**Re: Sundaram Office Bldg Grading and Drainage Plan**  
**Engineer's Stamp dated 7-17-08 (H11/D003A)**

**Re: Sundaram Office Building, 6130 Iliff Rd. NW, Traffic Circulation Layout  
Architect's Stamp dated 6-04-08 (H-11/D003A)**

**RE: SUNDARAM OFFICE BUILDING GRADING AND DRAINAGE PLAN  
ENGINEERIN'S STAMP DATED 5-22-08 (H11/D003A)**

**Re: Sundaram Office Bldg Grading and Drainage Plan**  
**Engineer's Stamp dated 5-22-08 (H11/D003A)**

Office Building  
 LOT 263-A-2 Estancia Drive N.W.  
 Albuquerque, N.M.  
 A001

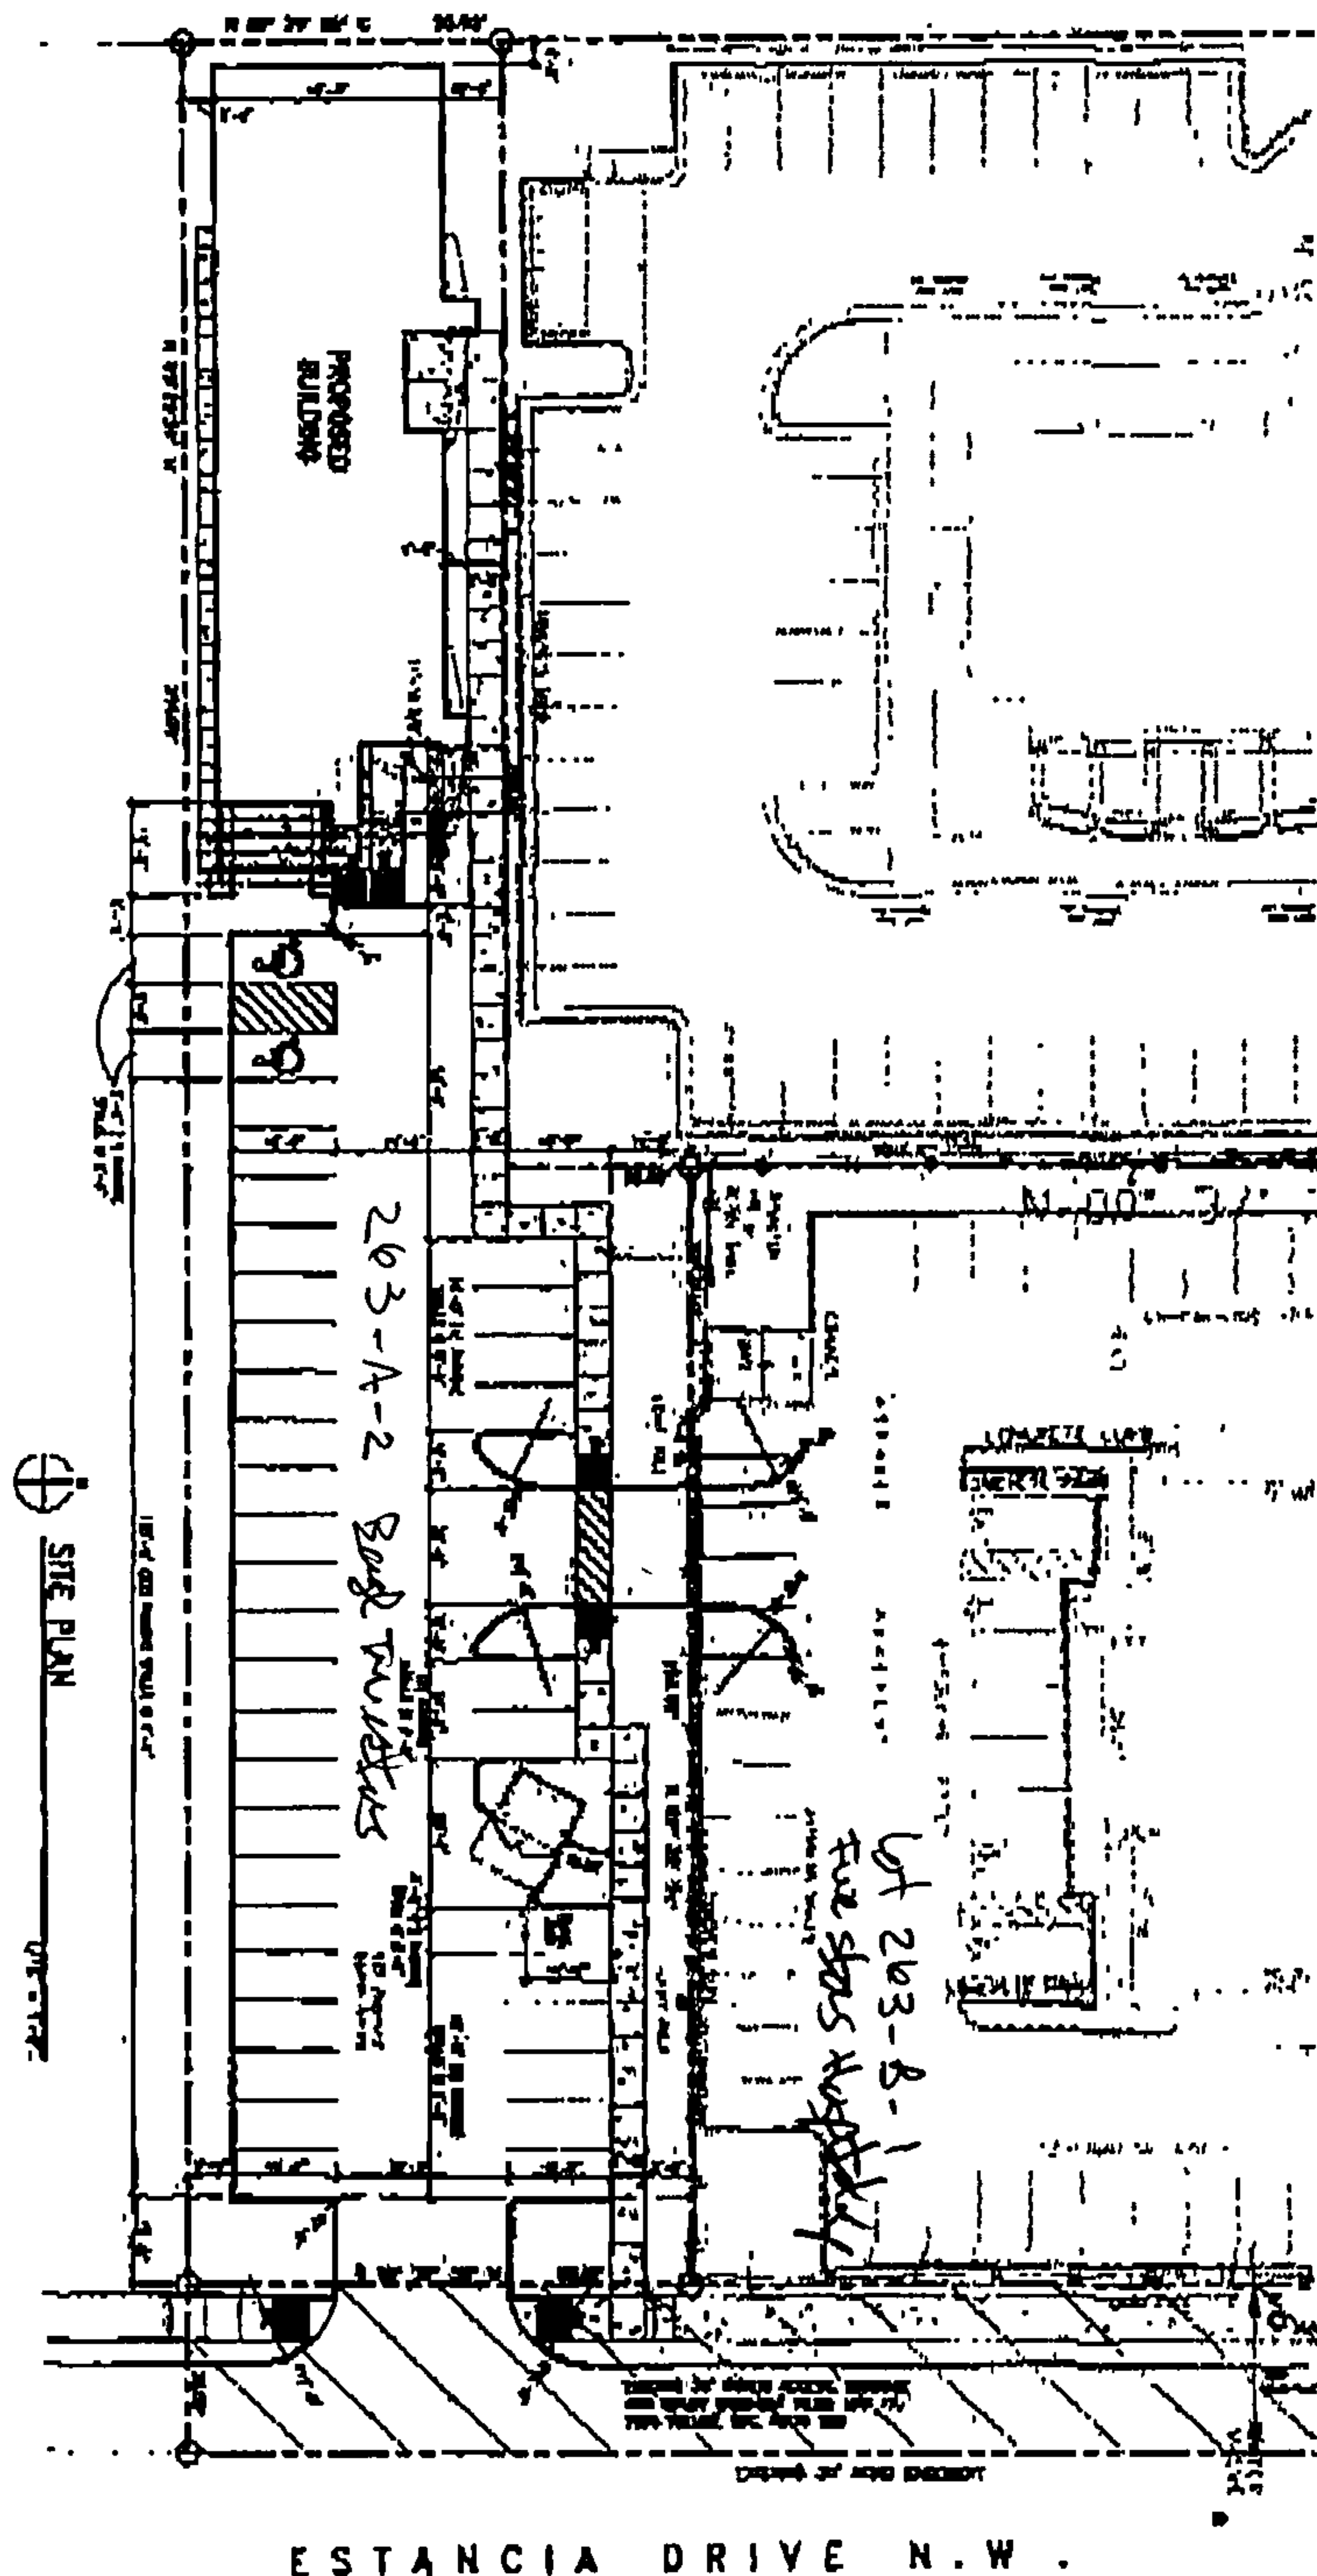
1. Clarify existing versus proposed conditions. Is the sidewalk along Estancia Drive existing or proposed?
2. A build note is needed for the curb cut on Estancia Drive. This build note should reference City Standard 2426.
3. Add the following text to keyed note 18: "...per City Standard 2426 with truncated domes."
4. Define the maximum slope for all wheelchair ramps (1:12).
5. ~~Written permission from the owner of lot 263-B-1 is required to perform work on that lot.~~ *Removed per Kevin Curran - see 2/27/09 Email*
6. A 24' drive aisle in lieu of a 20' drive aisle is required between the two lots.
7. Parking bumpers will be needed along the northern most parking stalls to keep the 6' clear space for the pedestrian access.
8. Include a six-foot wide pathway from the ADA parking stalls to the ramp at the entrance to the building.
